Drawing Name: SHOULDER HARNESS KIT

DESIGN <i>LE</i>	DRAWN BY <i>LE</i>	<b>DART AEROSPACE LTD</b> HAWKESBURY, ONTARIO, CANADA	
CHECKED <i>GP</i>	APPROVED <i>[Signature]</i>	DRAWING NO. <b>DSI 9351</b>	REV. A SHEET 1 OF 1
DATE <b>06.09.15</b>	TITLE <b>SHOULDER HARNESS KIT</b>		SCALE NTS
REV A	DATE 06.09.15	DESCRIPTION NEW ISSUE

## **DART SERVICE INSTRUCTION**

**TO AMEND INSTALLATION INSTRUCTIONS IIN-D412-702 REV A, B OR C**  
REF. CANADIAN STC SH04-7  
REF. FAA STC SR01997NY

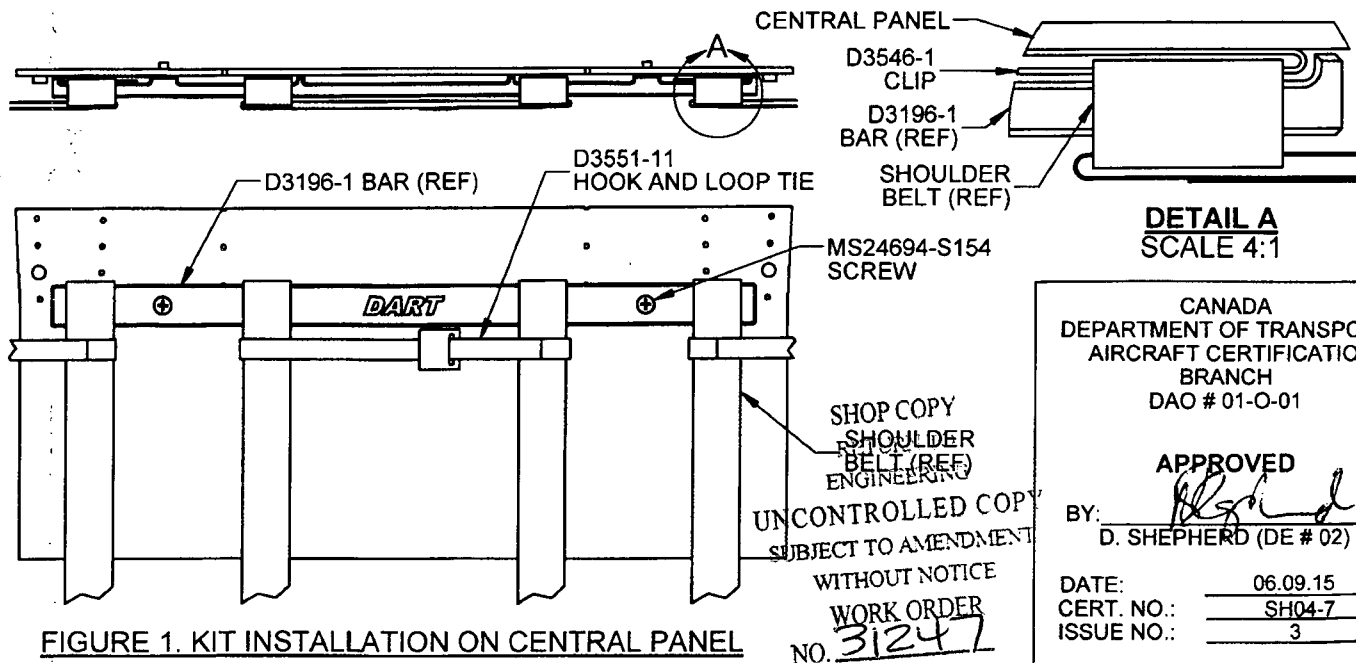
TO IMPROVE THE FIT AND VISUAL IDENTIFICATION OF SHOULDER HARNESS SETS, DSI 9351-011/-013/-015 SHOULDER HARNESS UPGRADE KITS ARE AVAILABLE FOR THE D412-702-011/-021/-013/-023/-015/-025/-017/-027 AND D214-702-035 SHOULDER HARNESS KITS AT CHANGE 1. INSTALLATION OF THESE KITS IS OPTIONAL.

1) REMOVE THE MS24694-S152 SCREWS FROM THE D3196-1 BAR ON THE CENTRAL PANEL. RE-INSTALL THE D3196-1 BAR WITH D3546-1 CLIPS USING MS24694-S154 SCREWS AS SHOWN IN FIGURE 1. ENSURE THAT THE SHOULDER BELTS ARE LOOPED THROUGH THE CLIP AS SHOWN IN DETAIL 'A'. TORQUE SCREWS TO 100-140 in-lbs (11.3-15.8 N-m). IT IS ACCEPTABLE TO USE LONGER MS24694-SXXX SCREWS AS REQUIRED TO ENSURE THAT THE D3196-1 BAR IS PROPERLY SECURED.

2) INSTALL THE D3551-11 HOOK AND LOOP TIES THROUGH THE FRONT LOOPS OF EACH SET OF SHOULDER BELTS. INSTALLATION ON THE 4-MAN AFT FACING BENCH IS AT THE DISCRETION OF THE INSTALLER. ENSURE THAT THE 'LOOP' SIDES OF THE TIES ARE FACING OUTWARD FOR PASSENGER COMFORT. TIGHTEN OR LOOSEN THE TIES AS NEEDED (TRIMMING IS ACCEPTABLE).
